<b>Docket Number:</b>	06-AFC-09C
<b>Project Title:</b>	Colusa Generating Station - Compliance
<b>TN #:</b>	215092
<b>Document Title:</b>	Pacific Gas & Electric Company's Petition for Amendment for CGS - Rotating Intake Screens
<b>Description:</b>	N/A
<b>Filer:</b>	Marie Fleming
<b>Organization:</b>	DayZen LLC
<b>Submitter Role:</b>	Applicant Representative
<b>Submission Date:</b>	12/22/2016 12:17:35 PM
<b>Docketed Date:</b>	12/22/2016

# PETITION TO AMEND

COLUSA GENERATING STATION (06-AFC-9C)

SUBMITTED BY: **PACIFIC GAS & ELECTRIC  
COMPANY (PG&E)**

FIGURE 2-3 Location of the Pull Boxes

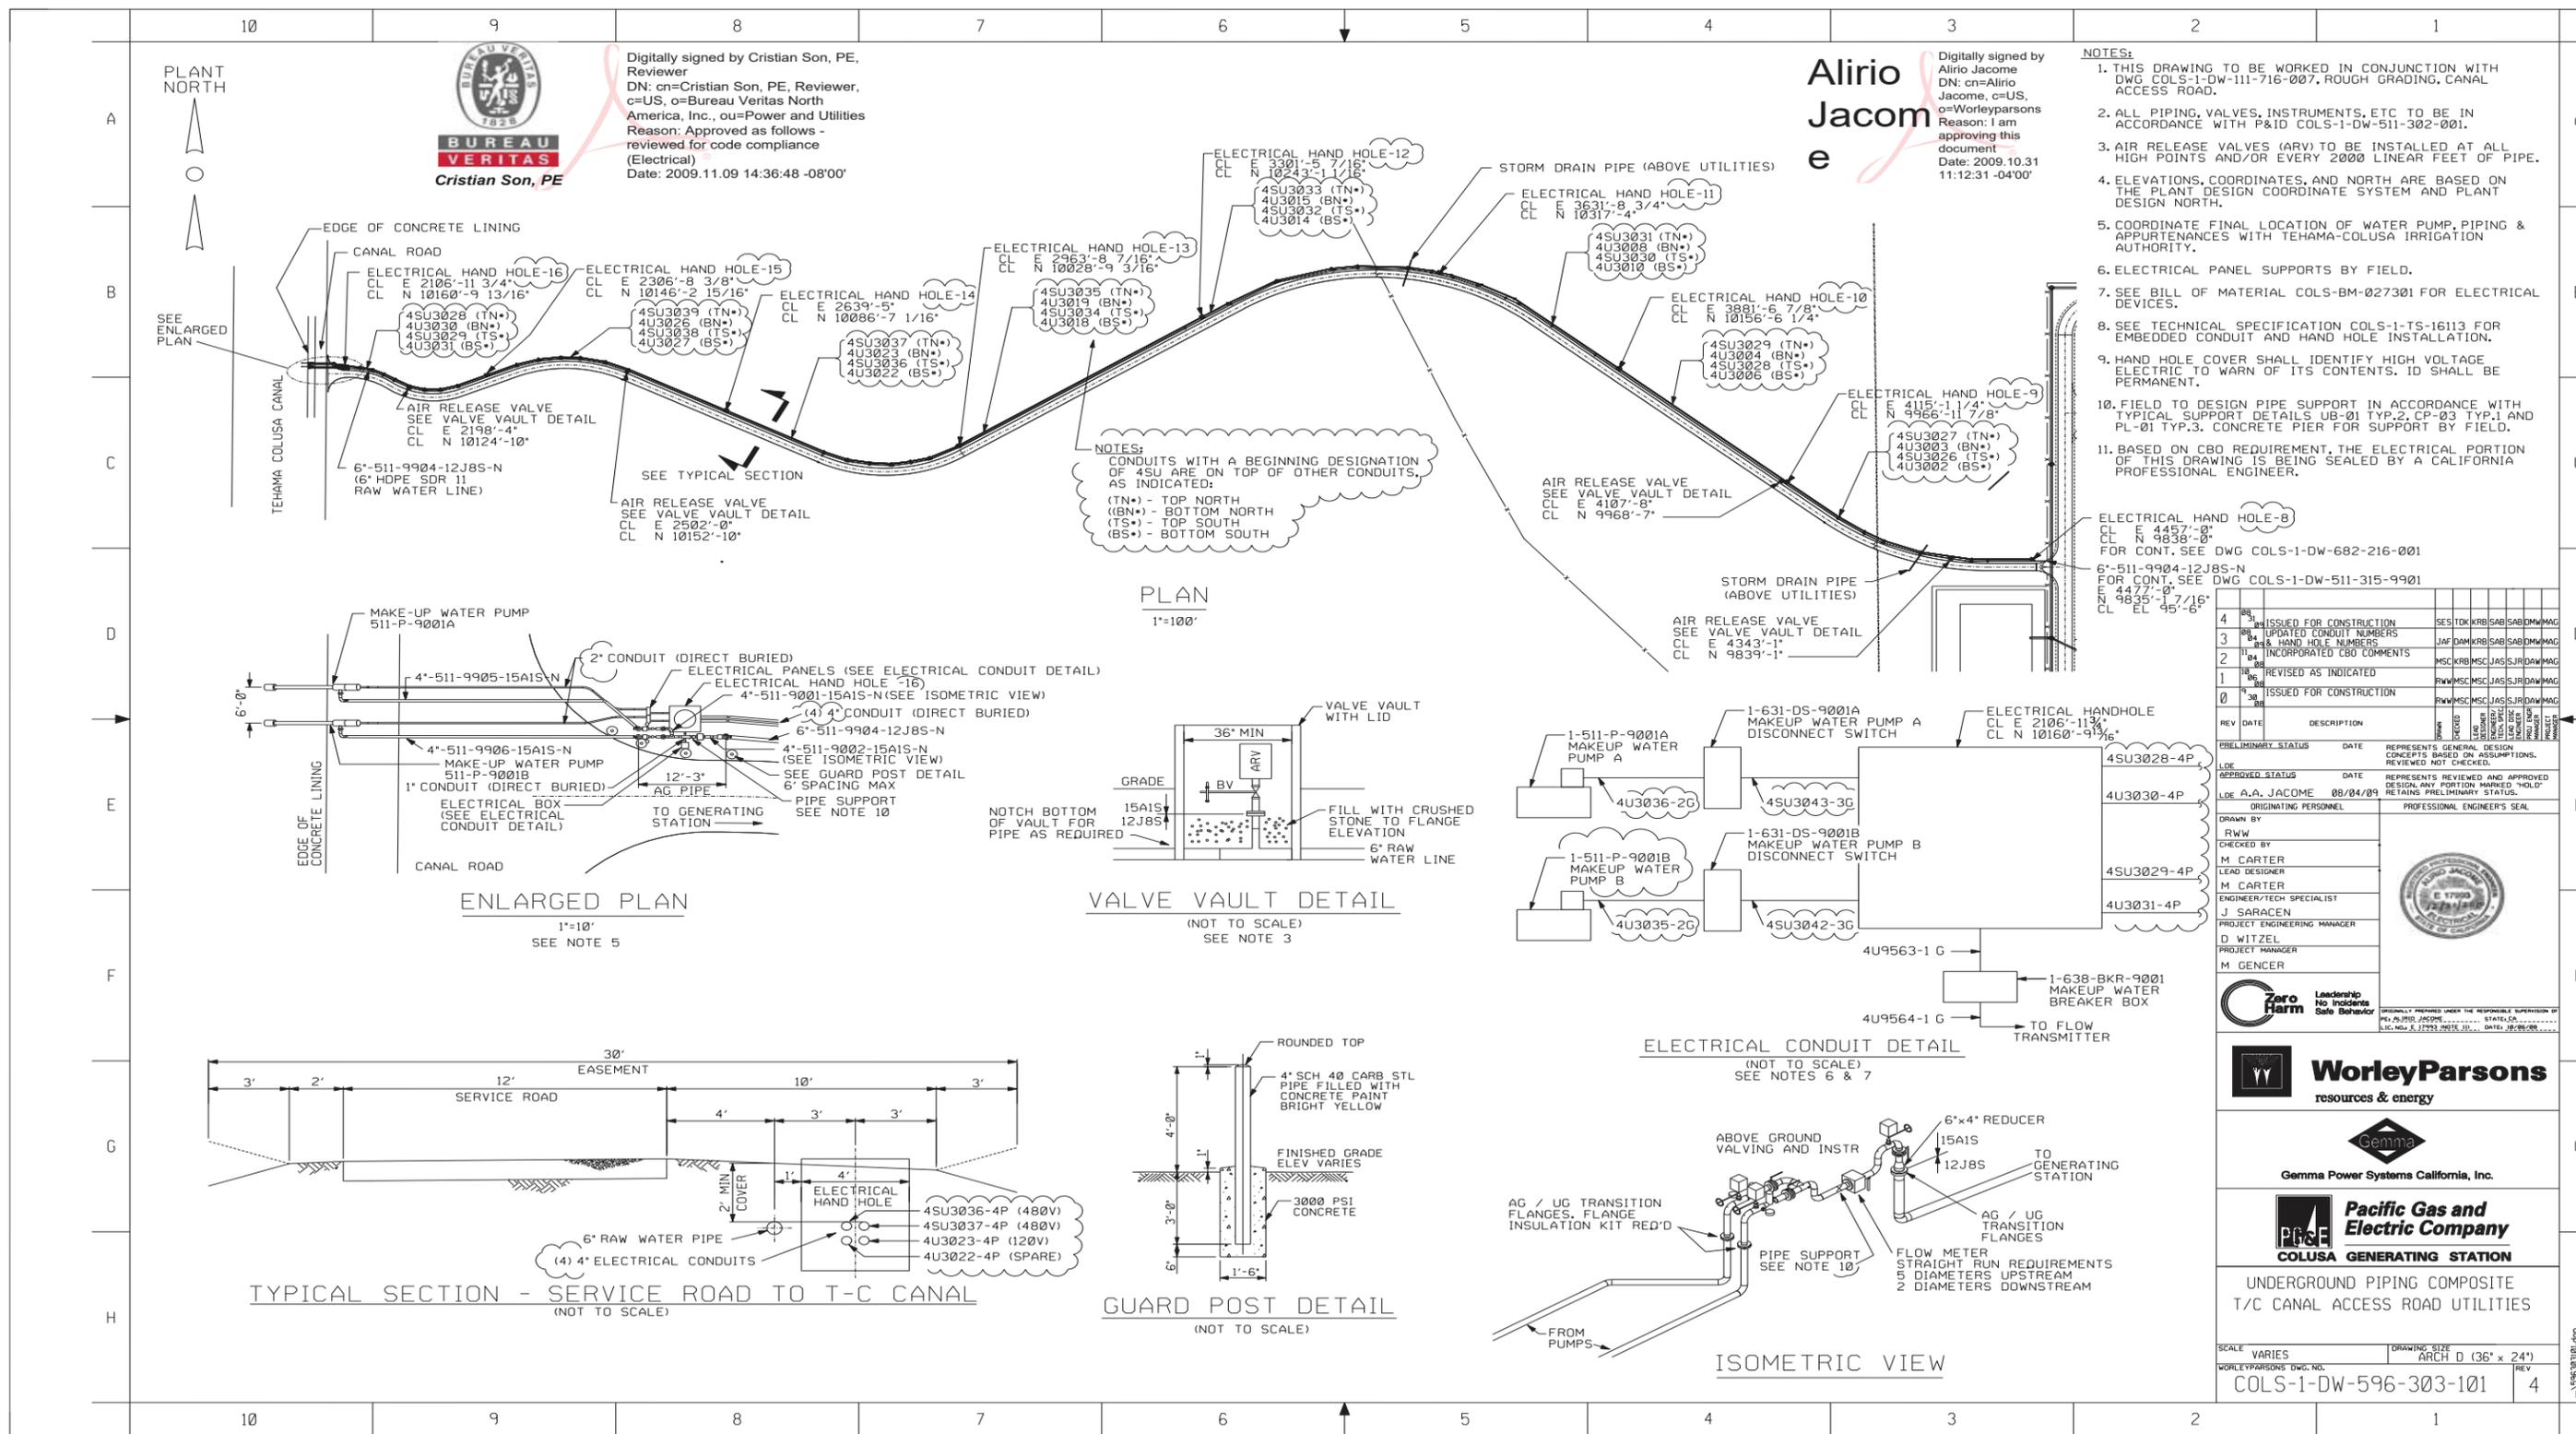
Construction of the compressor pad, installation of the compressor and light fixtures, and hose and electrical will all be performed from the canal access road. See Figure 2-3 for the locations of the pull boxes.
